ZONING CHANGE REVIEW SHEET

CASE: C14-2010-0015 (The Domain Rezoning-Endeavor) **P. C. DATE:** August 10, 2010

**MEMORANDUM**

SUBJECT: C14-2010-0015 (Endeavor Domain)

Shared Lane Marking

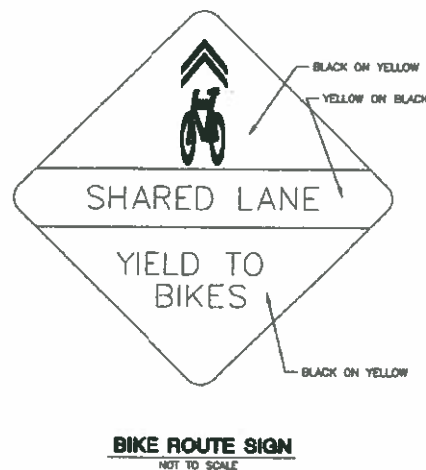
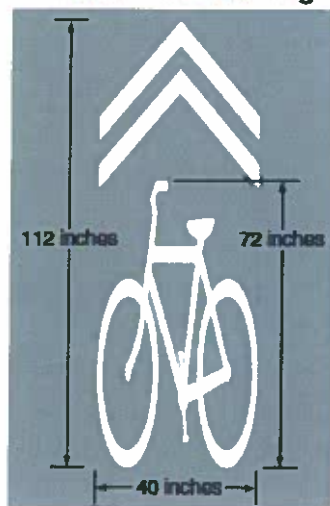
1. Provide bicycle facilities for the project by routing shared lane markings (sharrows) and multi-use (hike and bike) trails through the project as detailed in the attached exhibit, and in compliance with the following standards:

- Shared lane markings shall be installed on roadways shown as sharrow routes on the attached exhibit. The shared lane markings shall be placed with the tip of the chevron in the middle of the lane as measured from face of curb.
- A sharrow facility sign as shown below at a size no smaller than currently installed by Simon on Kramer Ln. shall be placed at least 2 per block (one on each side of the street)
- Angled and head in parking prohibited on either side of roads with required sharrows. Reverse angled parking is acceptable.
- Shared lane markings (sharrows) shall be installed within one year of this agreement on existing roadways and installed at the same time as new roadways are constructed.
